Re: Minor Project Refinement No. 7 for the South Orange County Reliability Enhancement Project.

ATTACHMENT A MPR-7 Form

South Orange County Reliability Enhancement Project CPUC Minor Project Refinement Form

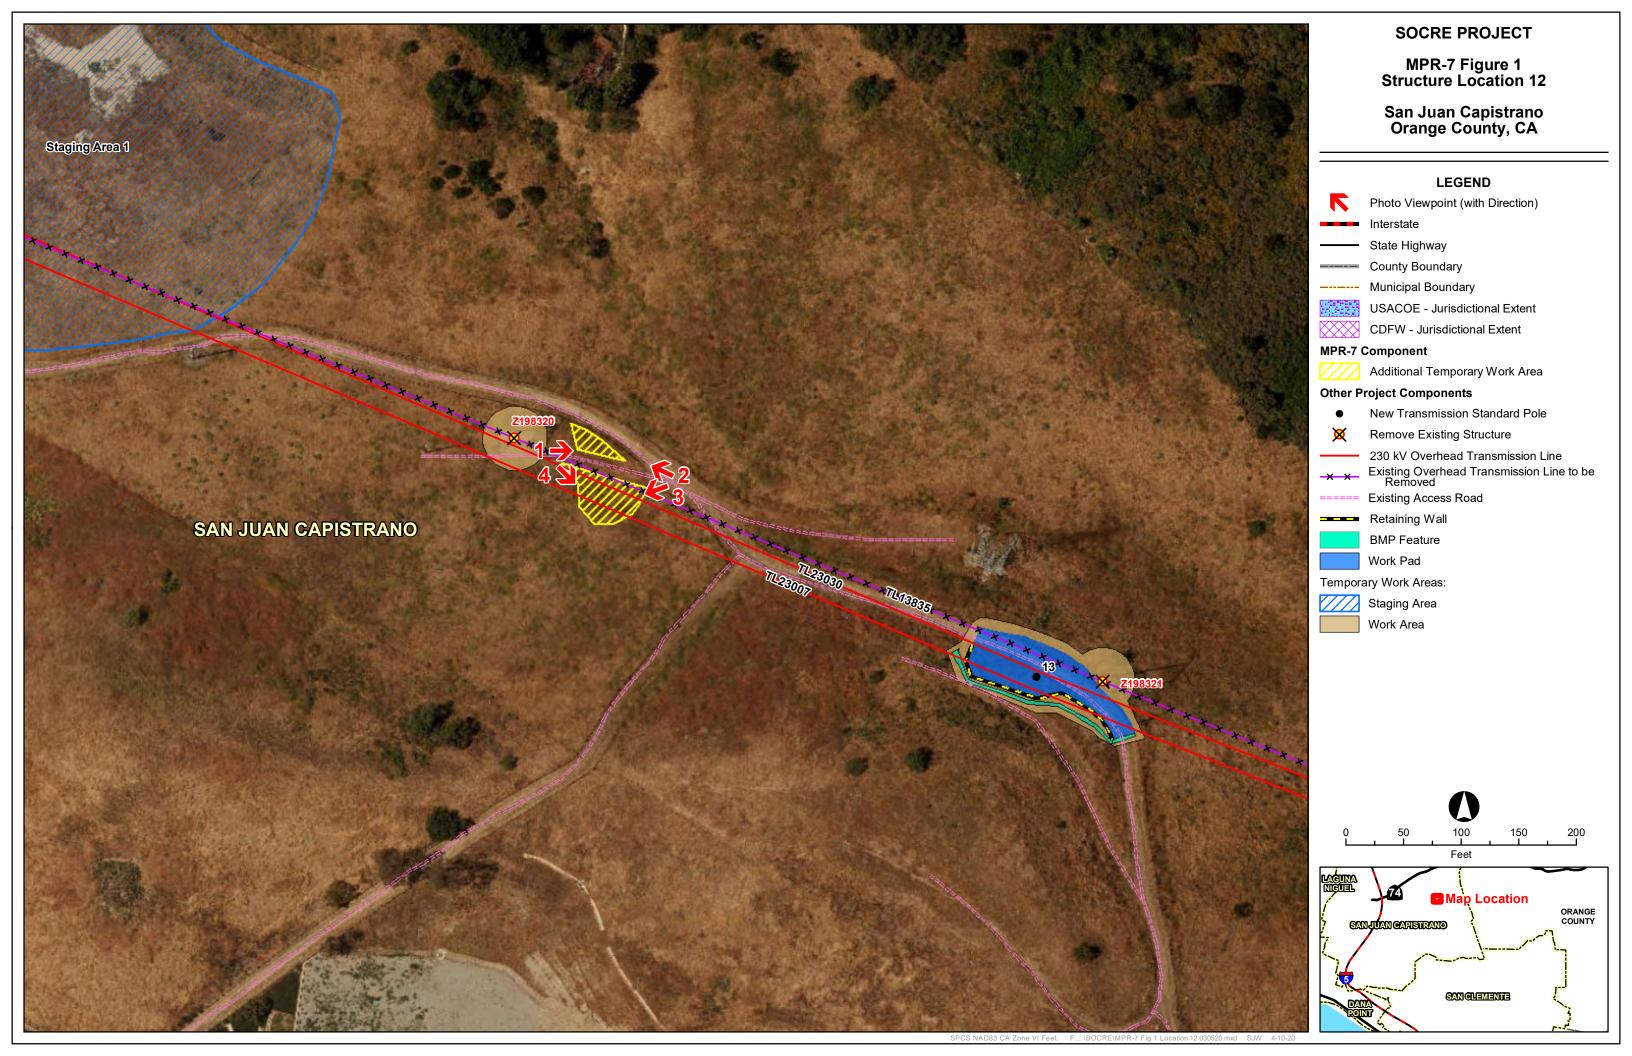
COA-1. The extent of the MPR-7 additional work area will be limited to the area shown on the figure titled "SOCRE PROJECT, MPR-7 Figure 1, Structure Location 12", located adjacent to the access road west of Location 13 and east of existing structure Z198320, and will be used to provide safe and practical access to complete construction activities east of I-5, primarily for Locations 11-13. MPR-7 activities will only occur within the SDG&E right-of-way.
